Access Compliance Report

Public Rights-of-Way

Intersection ID: 27774	Main Street: BRYANT_FARMS_RD	Cross Street: HOUSTON_RIDGE_RD	Location: SE
ADA ID: 3B21E0E3FDDC	Ramp Type: PerpDiag	Initial Pass/Fail: Fail	Overall Compliance: No
Severity Score: 12.5			
Codes/Mitigation Info/Possible Solution		Field Measurements/Component Compliance

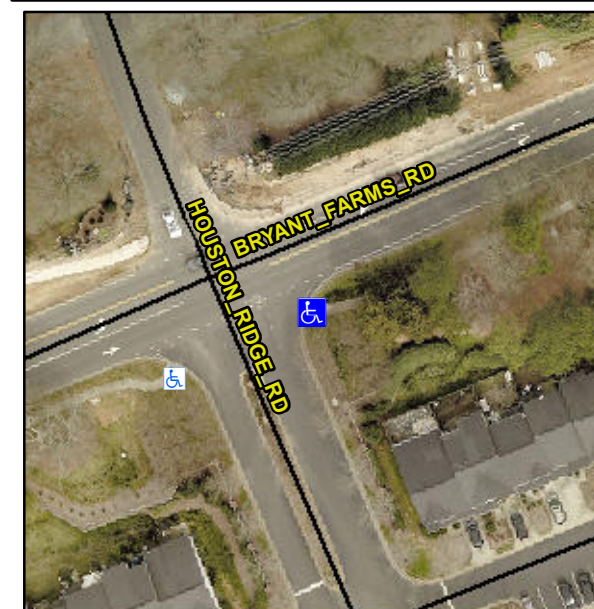
Not Found, R304.5.3

Compliance	Description	Data	Compliance	Description	Data
N/A	Ramp Length (in)	52.0	Yes	Ramp Slope (%)	5.2
Yes	Ramp Width (in)	48.0	No	Ramp XSlope (%)	5.1
N/A	Flare Type LT	N/A	N/A	Flare Type RT	N/A
N/A	Flare Slope LT (%)	N/A	N/A	Flare Slope RT (%)	N/A
N/A	Flare Traversable LT?	N/A	N/A	Flare Traversable RT?	N/A
N/A	Landing Length (in)	N/A	N/A	DWS Provided?	N/A
N/A	Landing Width (in)	N/A	N/A	DWS Contrast?	N/A
N/A	Landing Slope (%)	N/A	N/A	DWS Length (in)	N/A
N/A	Landing X Slope (%)	N/A	N/A	DWS Full Width?	N/A
N/A	Landing Curb? (Y/N)	N/A	N/A	DWS Offset (in)	N/A
N/A	Shared Landing?	N/A			
N/A	Gutter Ponding?	N/A	N/A	Gutter Slope (%)	N/A
N/A	Gutter Lip Ht (in)	N/A	N/A	Gutter X Slope (%)	N/A
N/A	Painted X Walk1?	No	N/A	Painted X Walk2?	No
	X Walk 1 Direction	To N		X Walk 2 Direction	To SW
N/A	X Walk 1 Width (in)	N/A	N/A	X Walk 2 Width (in)	N/A
	X Walk 1 Slope (%)	7.1		X Walk 2 Slope (%)	0.6
	X Walk 1 X Slope (%)	0.5		X Walk 2 X Slope (%)	7.6

Remove & Replace Curb Ramp With Two New Directional Ramps or Equivalent.
